**DEPARTMENT OF THE ARMY
WILMINGTON DISTRICT, CORPS OF ENGINEERS**

Action ID No. 1993-02466

Reference the Department of the Army (DA) individual permit (IP) Action SAW-1993-02466, issued April 18, 2019 to construct a new US 70 bypass of Havelock, North Carolina in Craven County, North Carolina.

Subject: Modification of 401 Water Quality Certification Pursuant to Section 401 of the Federal Clean Water Act and Neuse Buffer Authorization with ADDITIONAL CONDITIONS for the proposed construction of the Havelock Bypass in Craven County, TIP R-1015.
NCDWR Project No. 20181598 v.2

PROJECT REFERENCE NO. R-1015	SHEET NO. NE-04
RW SHEET NO.	
ROADWAY DESIGN ENGINEER	HYDRAULICS ENGINEER
DOCUMENT NOT CONSIDERED FINAL UNLESS ALL SIGNATURES COMPLETED

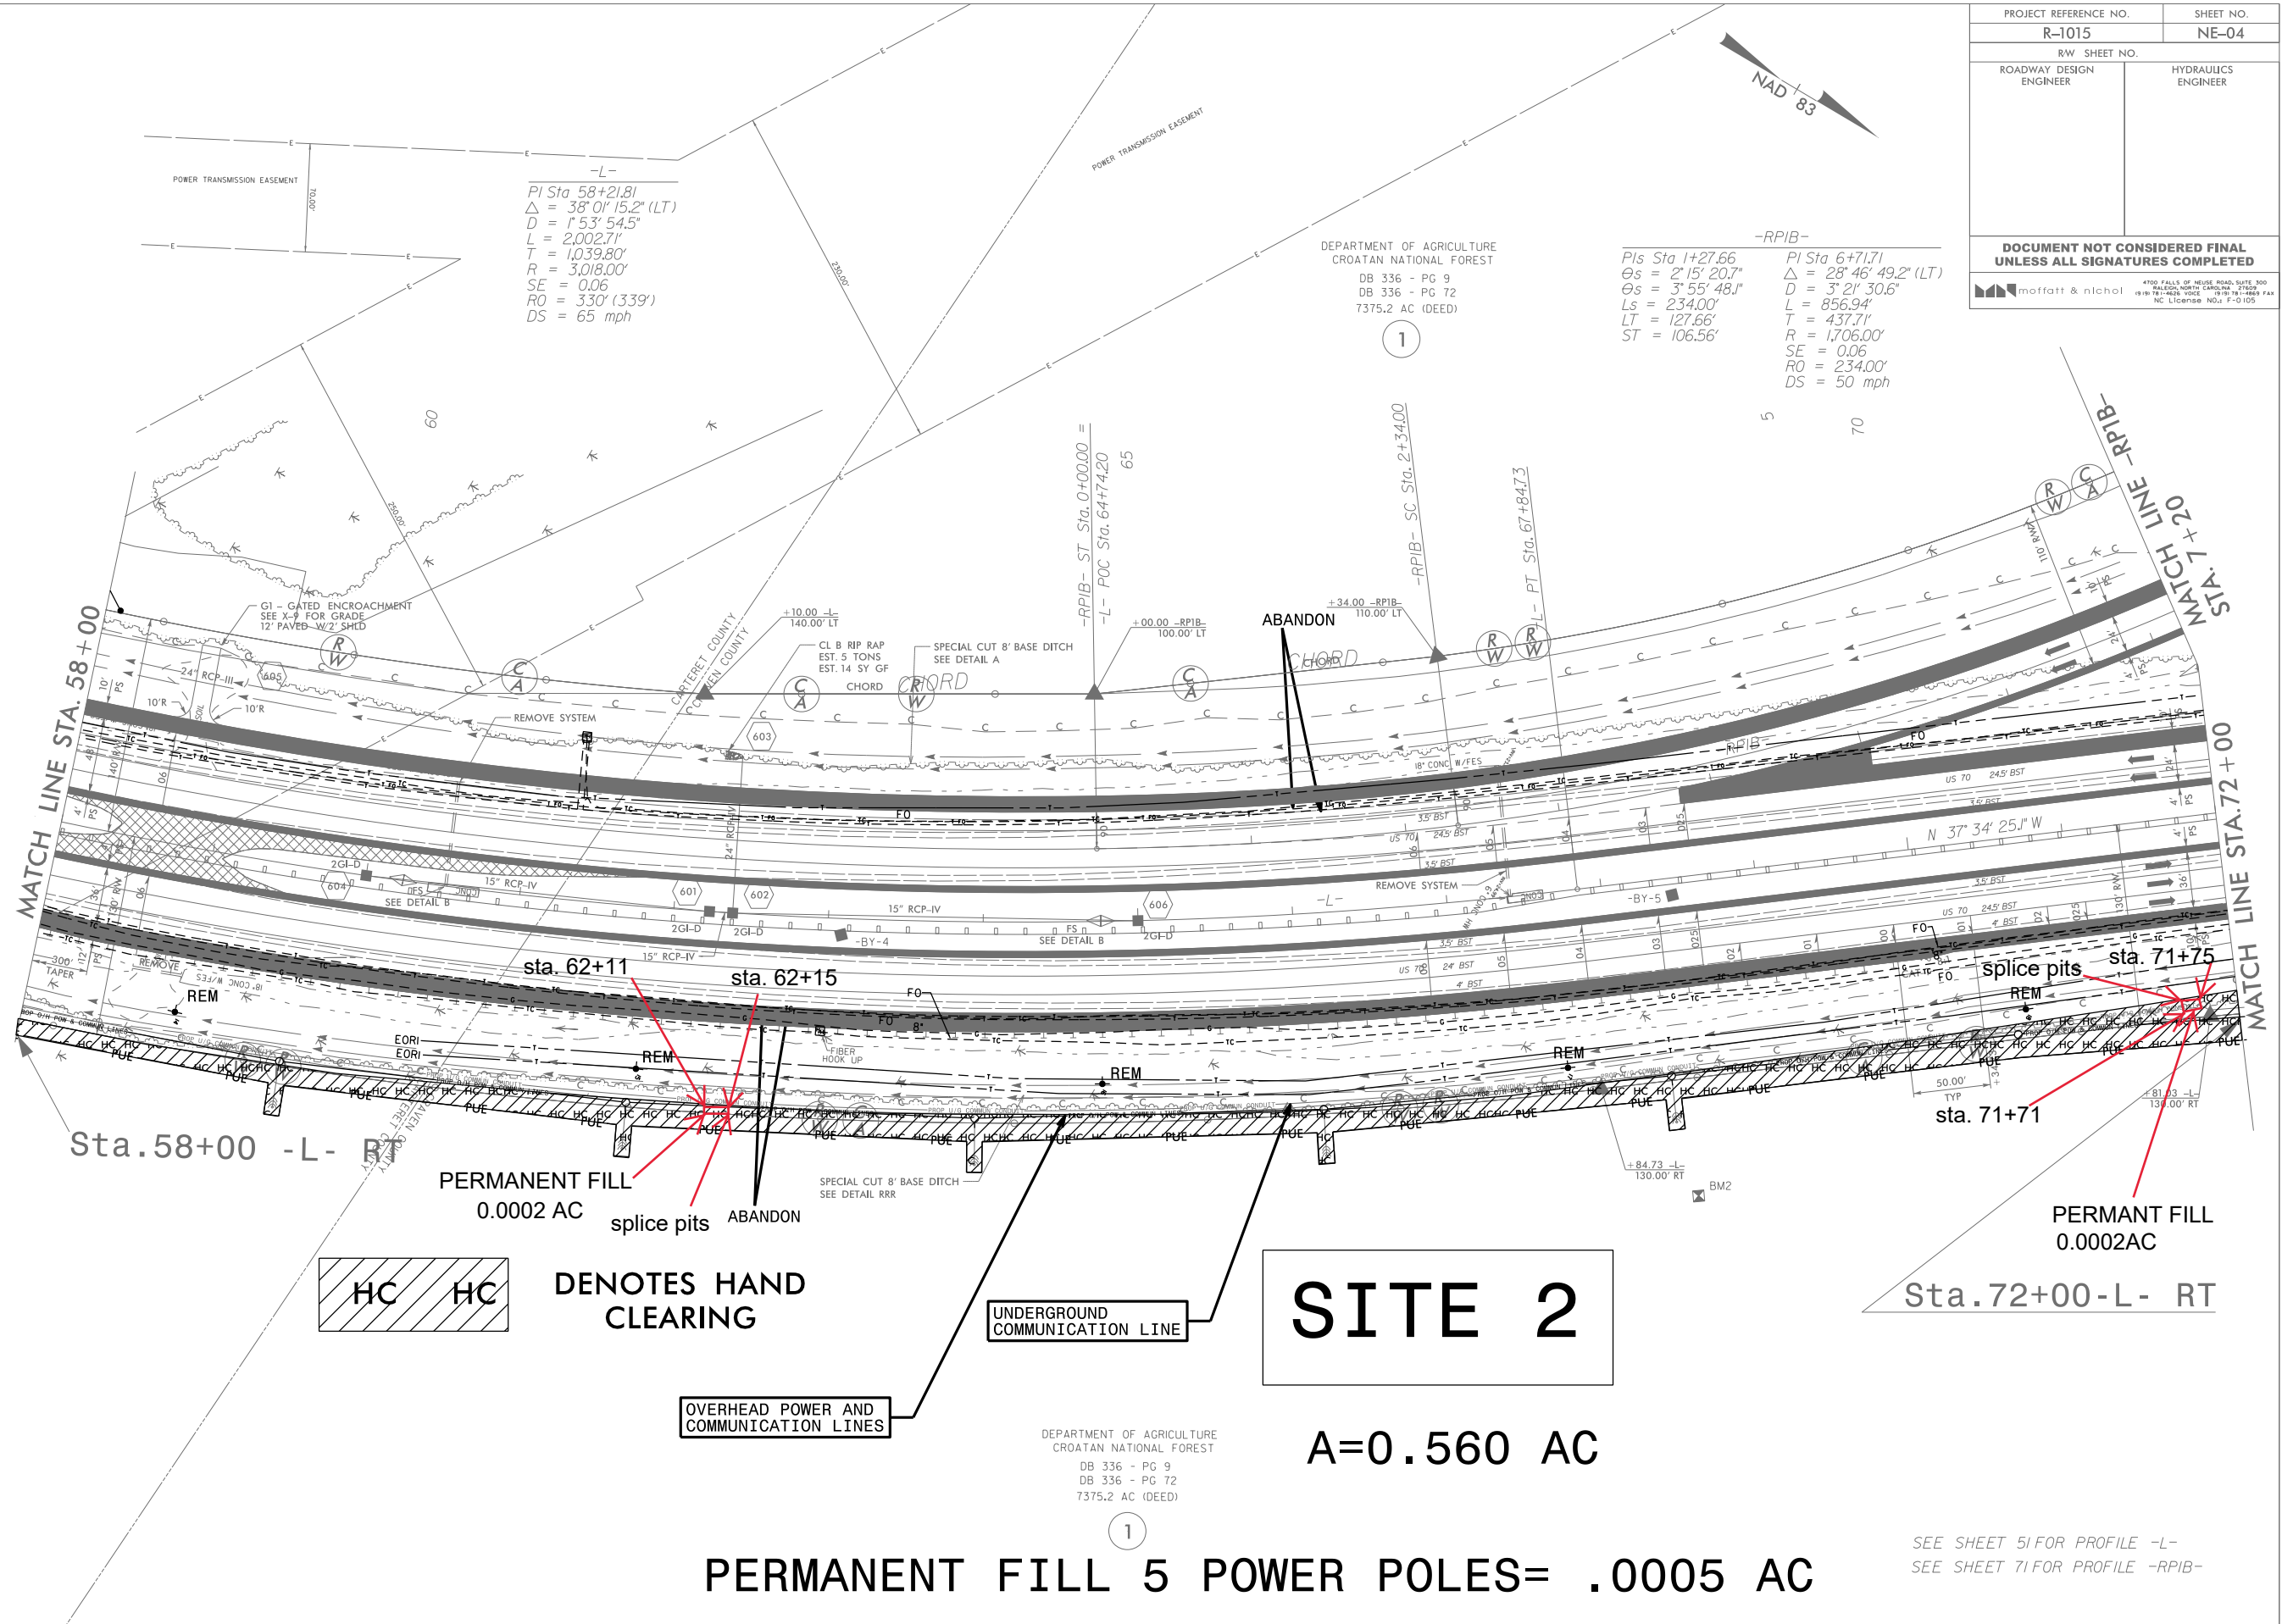
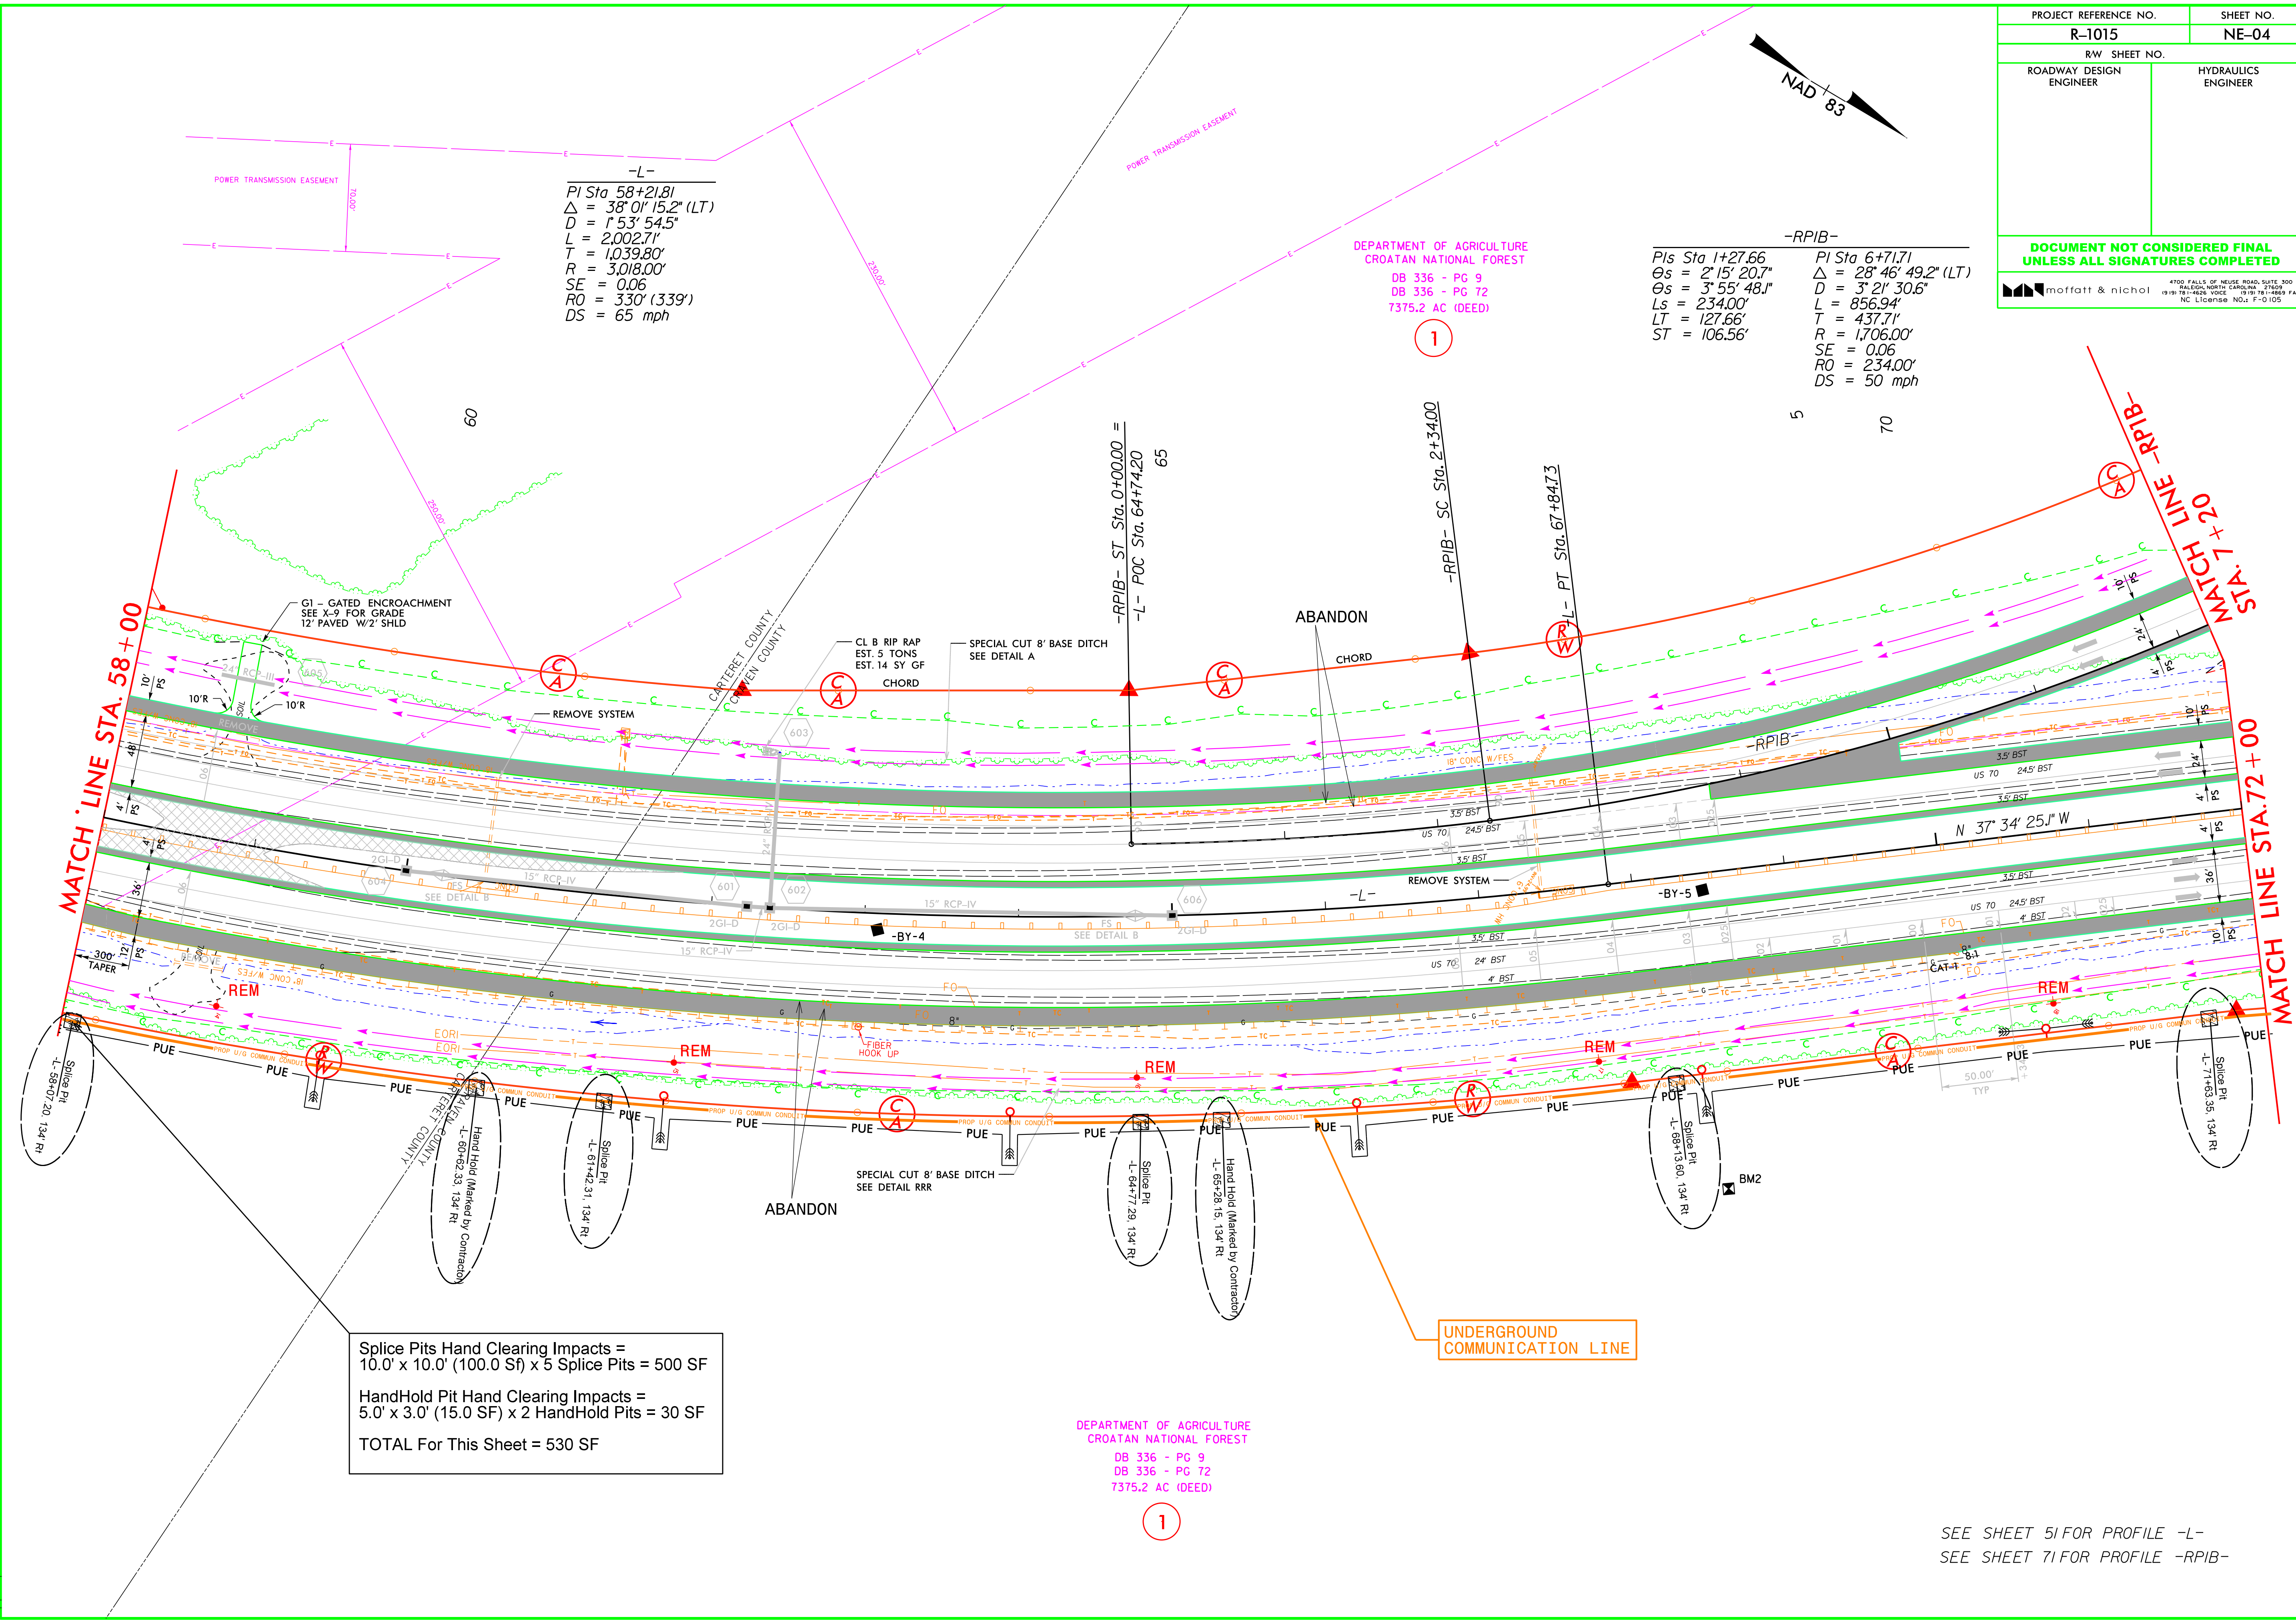
- Additional sheets have been prepared for the underground utility which requires additional impacts in wetland Sites 1, 2 and 3. The permit drawings showed underground utilities through these sections, but with no splice pits or hand holes, which are required. These supplemental drawings were revised by Division 2 to show the permanent hand holes and temporary splice pits with the total impacts required. These totals are not included in the summary sheet prepared by Hydraulics Unit. Impacts shown on the supplemental permit drawings are as follows:

- = NE-03, 400 s.f. for splice pits and 15 s.f. for hand holes
 - = NE-04, 500 s.f. for splice pits and 30 s.f. for hand holes
 - = NE-05, 600 s.f. for splice pits and 30 s.f. for hand holes
